**STAFF REPORT**  
**COMMUNITY DEVELOPMENT DEPARTMENT**

HEARING DATE: December 5, 2023

SUBJECT: FP-2023-0014  
Pinedale Subdivision - FP

B. Final Plat (dated: 10/2022)

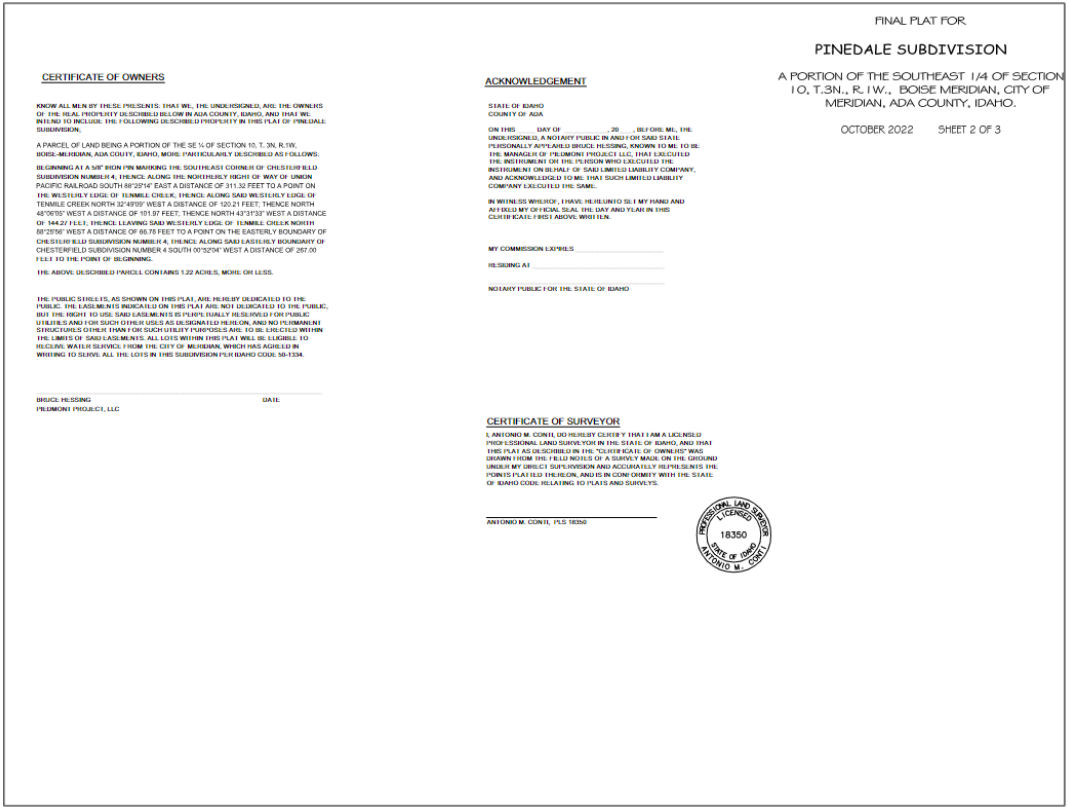
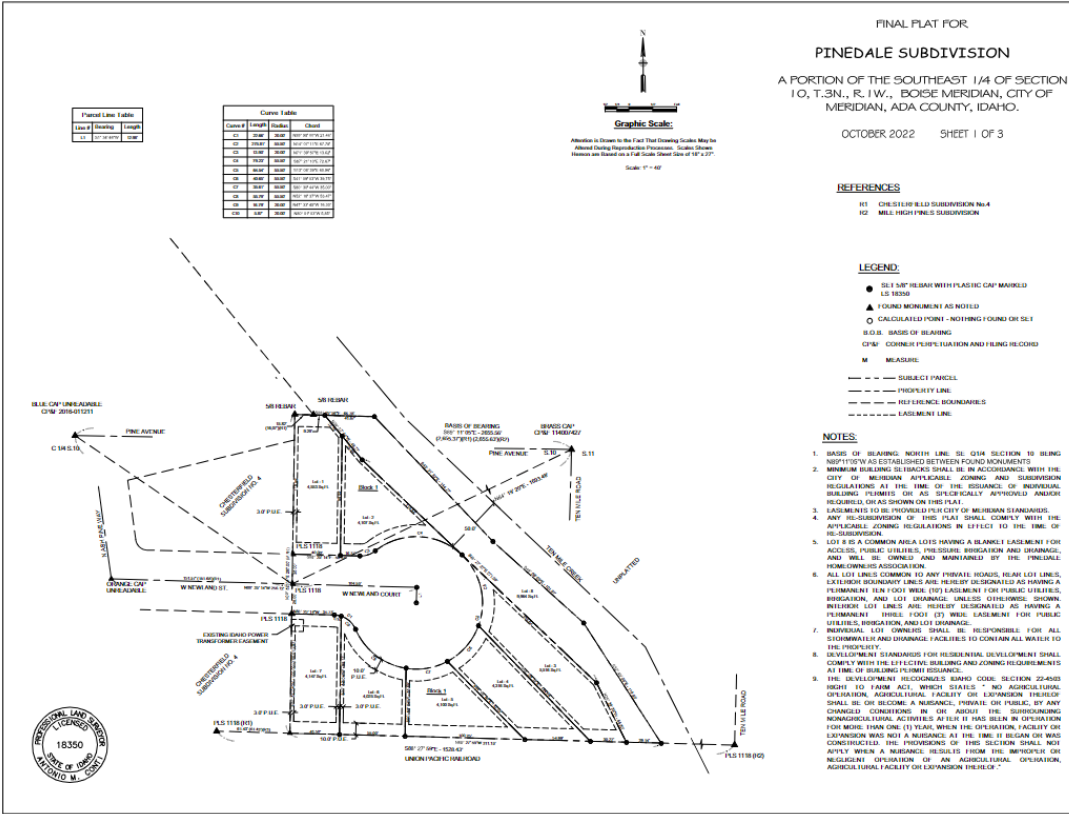
- a. The Land Surveyor shall sign and date the seal.
  - b. The Land Surveyor's business name and address shall be included on the plat.
  - c. Revise Note #2: remove any wording referencing setbacks on the plat ("OR AS SHOWN ON THIS PLAT").

- d. Revise the final plat to include 5-foot P.U.E. interior lot lines, maintaining a 5-foot setback along each lot in accordance with the R-8 zoning district.

- e. Revise Note #6: with "INTERIOR LOT LINES ARE HEREBY DESIGNATED AS HAVING A PERMANENT FIVE (5') WIDE EASEMENT FOR PUBLIC UTILITIES, IRRIGATION, AN LOT DRAINAGE.

- f. Add Note #10: "The subdivision is subject to the existing Development Agreement and include the DA instrument number (DA Inst. #2023-024580)."
  - g. Revise street names on the plat per the street name approval from Ada County dated July 2, 2023.
